## FVG9401<sup>+</sup> and KA9121<sup>+</sup> with new safety functions

The control units of the FVG9401 and KA9121 are from now on equipped with extended safety functions.

Wiring example:

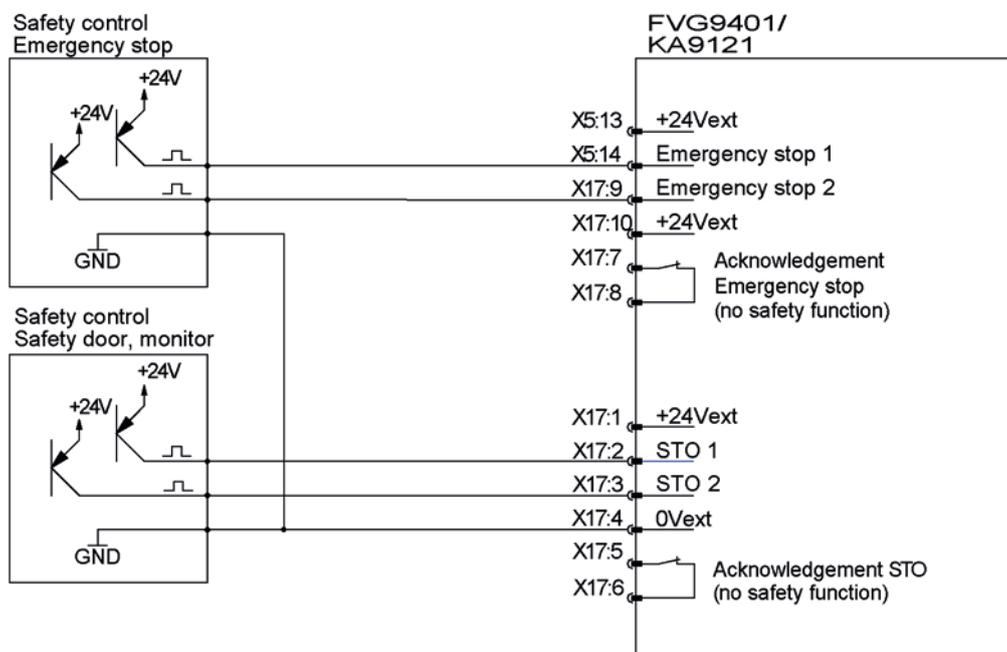
**Attention:** The configuration of X17 has been changed compared to older devices. In case the option SLS is not existing X15 must not be wired.
